Environmental Impact Statement for the Proposed National Enrichment Facility in Lea County, New Mexico

Appendices H through J

Final Report

Figure E-8 Average 24-Hour Concentrations of Pollutants in Extreme Winds from the West-Southwest

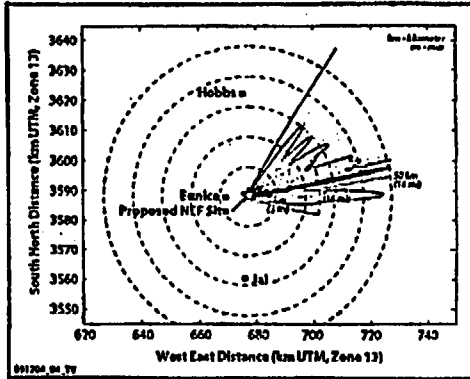
94. Page E-4, lines 64 and 65 - This sentence refers to Figure E-8 and states "This figure shows that a narrow plume would extend to the west from the proposed NEF source." However, Figure E-8 shows the plume extending to the east of the NEF site. Therefore, the sentence should be revised to "This figure shows that a narrow plume would extend to the east from the proposed NEF source."
